**KNOXVILLE HISTORIC ZONING COMMISSION
STAFF REPORT - CERTIFICATE OF APPROPRIATENESS APPLICATION**

PROPERTY ADDRESS: 26 Market Square 37902

FILE NO.: 3-E-19-HZ

LEVEL OF WORK: Level II. Construction of rooftop addition

View from 15-17 Market Square facade

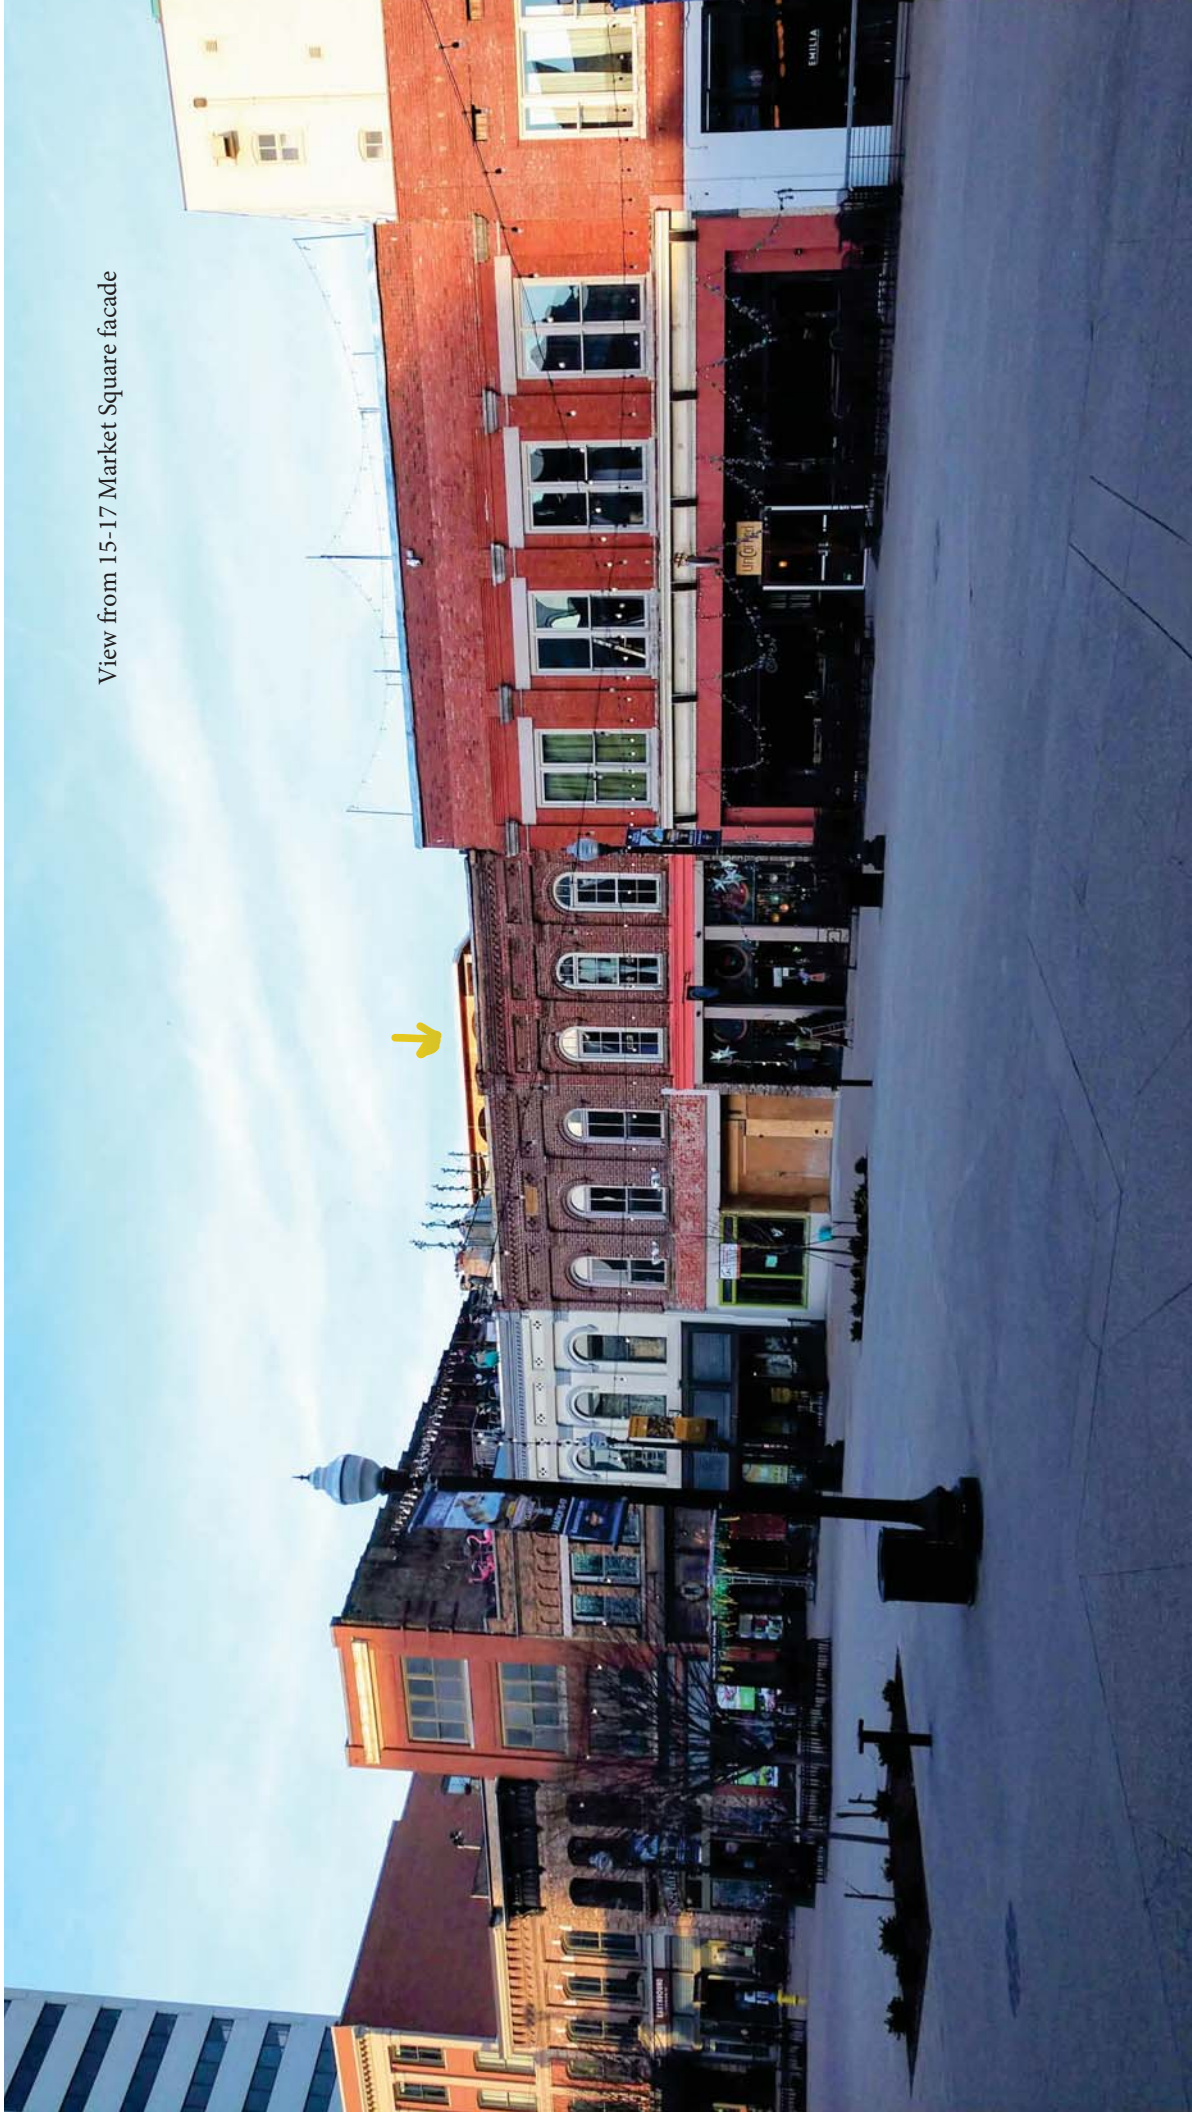
- 5) The shed-roofed stuccoed structure with arched doorways was not specifically designed to complement the materials, proportion or style of the historic architecture of the c. 1880s vernacular commercial building.

- 6) Attempting to allow a "limited" amount of visibility for rooftop construction, or to allow rooftop construction that "is not highly visible" would be an arbitrary measurement and would not be able to be consistently regulated by city building inspectors.

Based on the above findings, staff does not recommend approval of any visible rooftop structures from Market Square.
